STAFF REPORT 5-12-2021 REGULAR MEETING

APPLICATION NUMBER: 21-7217

ADDRESS: 4217 LINCOLN STREET

SCOPE: REMOVE STOOPS AND ONE (1) EXISTING FRONT PORCH; ERECT NEW FRONT PORCH SPANNING WIDTH OF FRONT FAÇADE

01 EAST ELEVATION
SCALE: 1/4" = 1'-0"

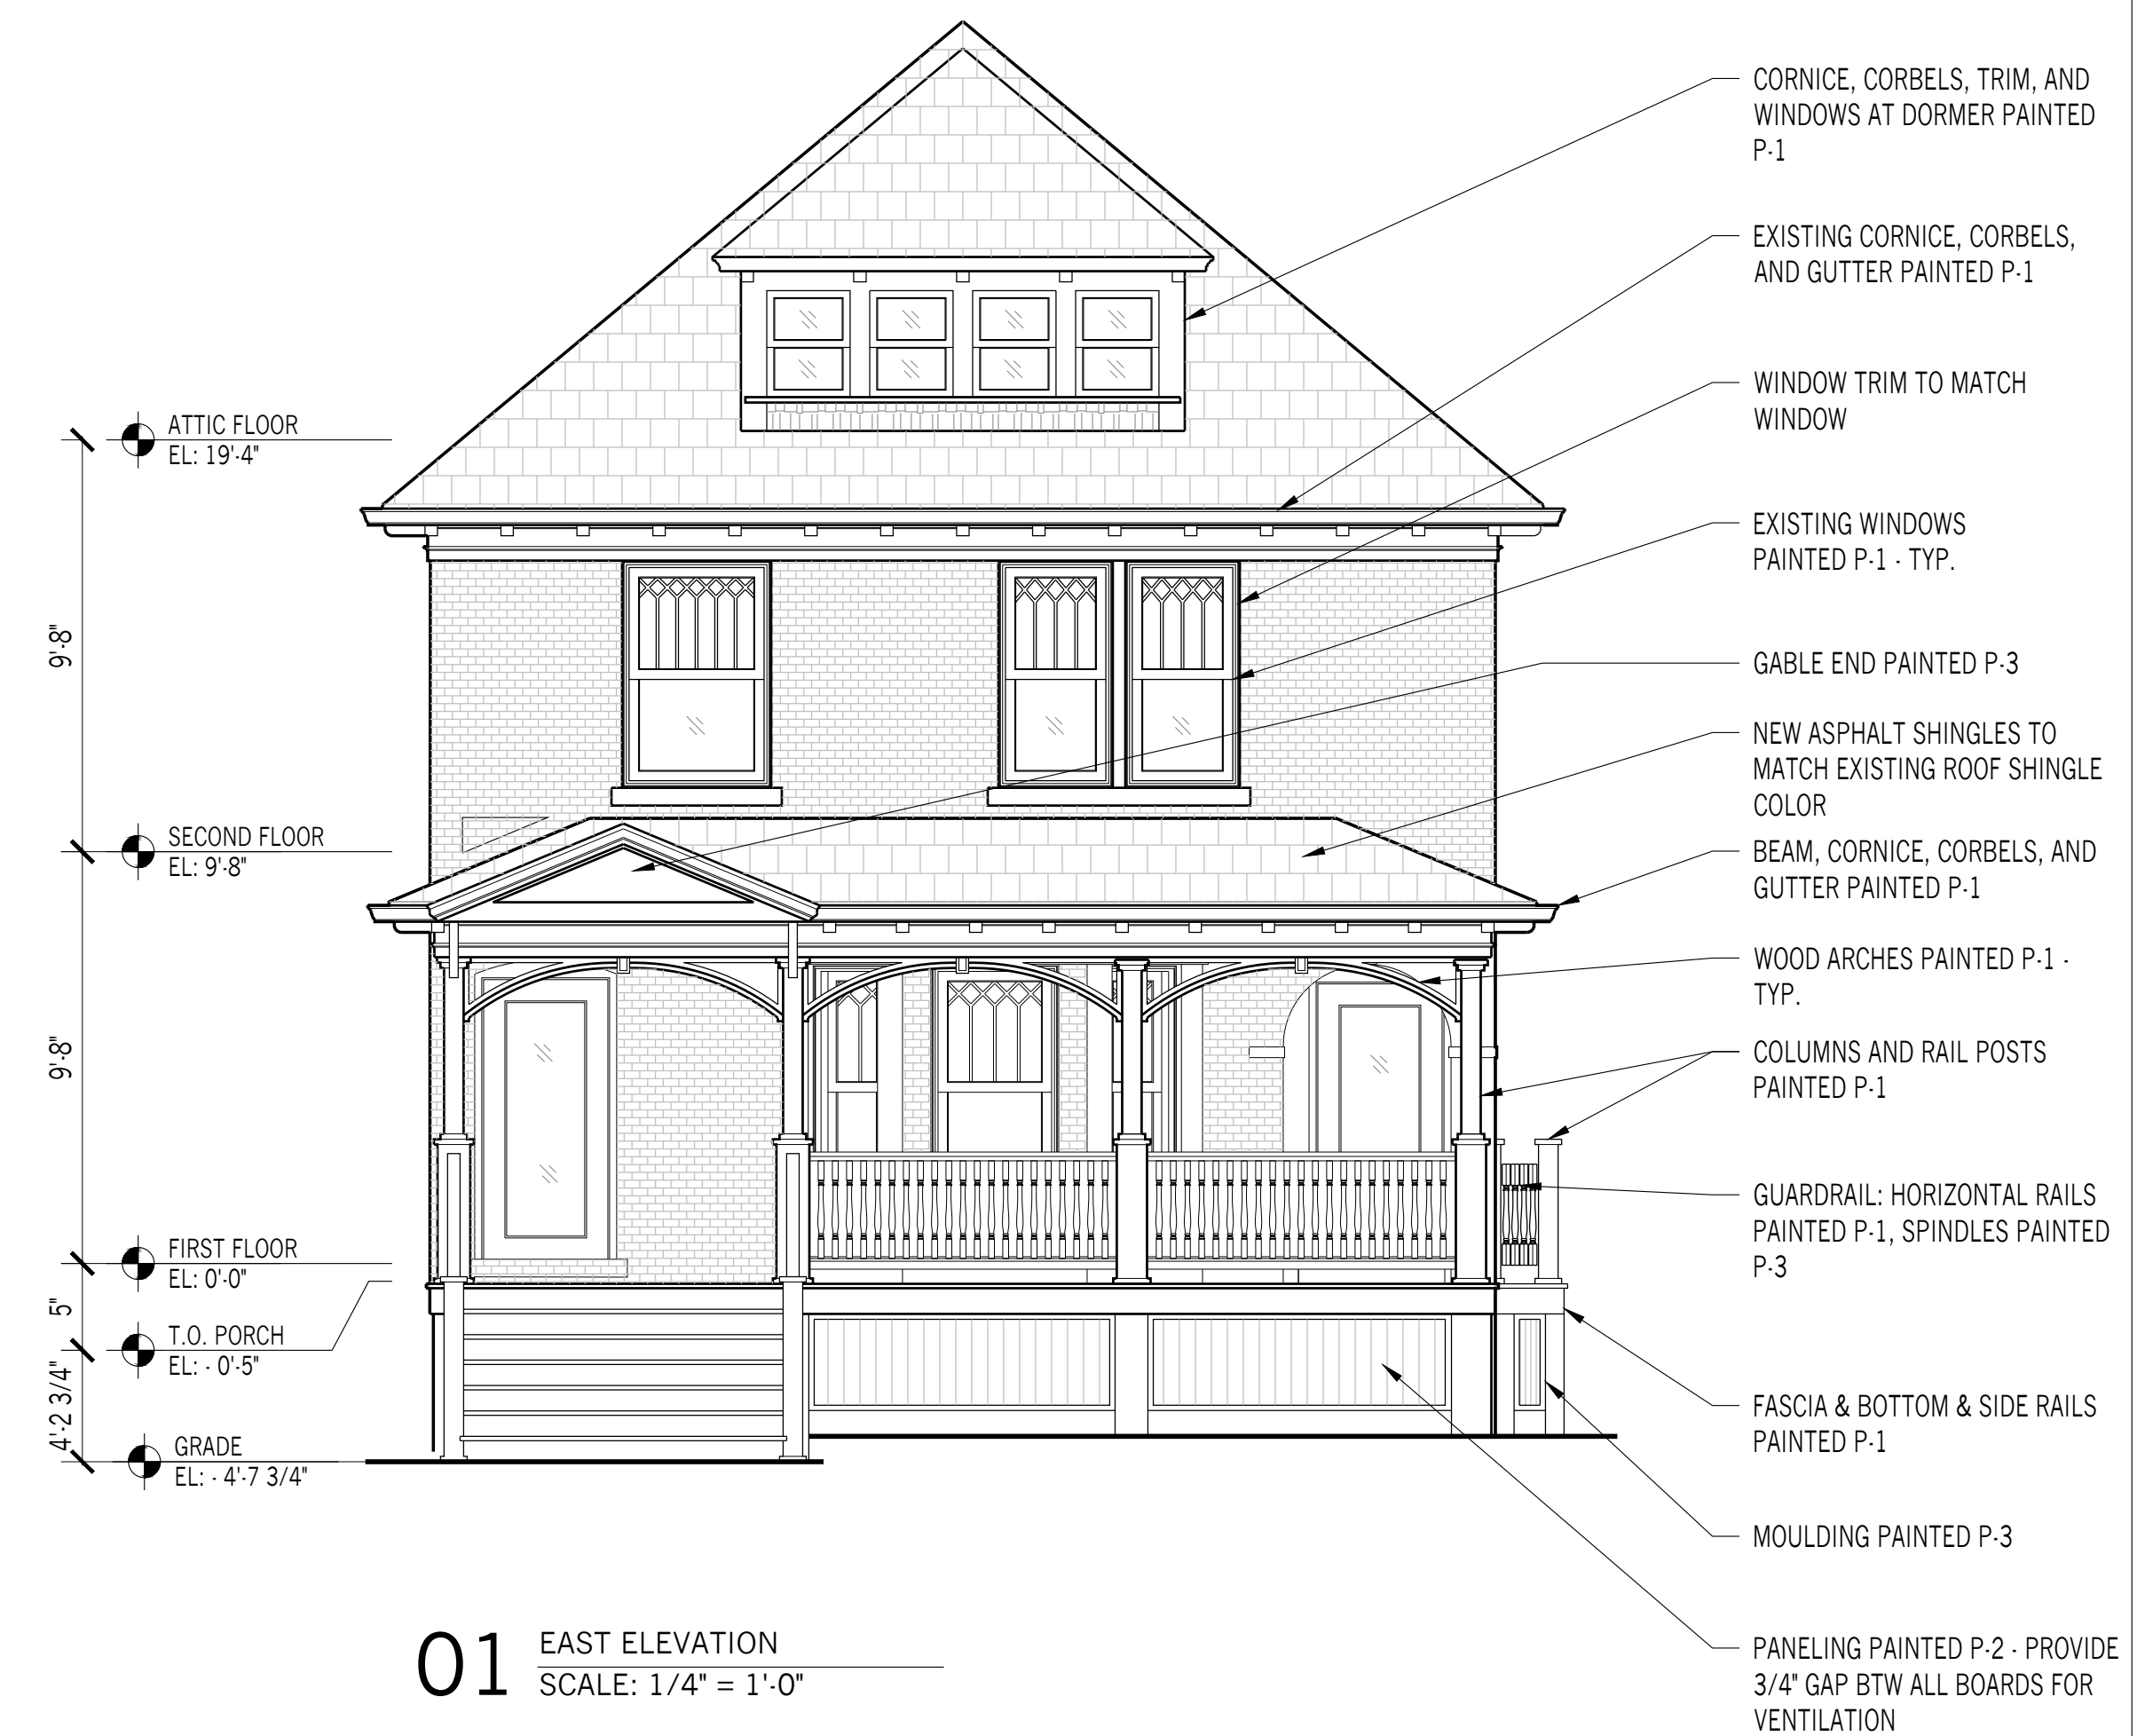
- The existence of two entries as well as the difference in architectural detail at the entries – the first floor unit entry presenting a more substantial projecting front porch and second floor unit entry featuring a recessed covered porch and more subdued detailing – are distinctive and important character-defining features of the property.

- The existing projecting bay at the center of the front façade, with its shed roof covered in cedar shake shingles is a distinctive and important character-defining feature of the property.

- It is staff's opinion that the proposal not only removes historic material but also alters the features that characterize the property and is therefore inappropriate as it doesn't meet the Secretary of the Interior's Standards for Rehabilitation nor the Elements of Design for this district. Specifically, the following excerpted Woodbridge Farm Elements of Design:

- Additionally, even if the removal of the historic materials and the alteration of features which characterize the property were appropriate, it is staff's opinion that the proposed new design is not substantially differentiated from the old and that it may create a false sense of historical development.

It is staff's opinion that the proposal to remove existing front porches and stoops as well as the removal of the cedar shake roof of the projecting bay is inappropriate with respect to the character of this property and its environment. Staff therefore recommends that the Commission issue a Denial for the proposed work because it does not meet the Secretary of the Interior's Standards for Rehabilitation and the Woodbridge Farm Elements of Design, especially Standards:
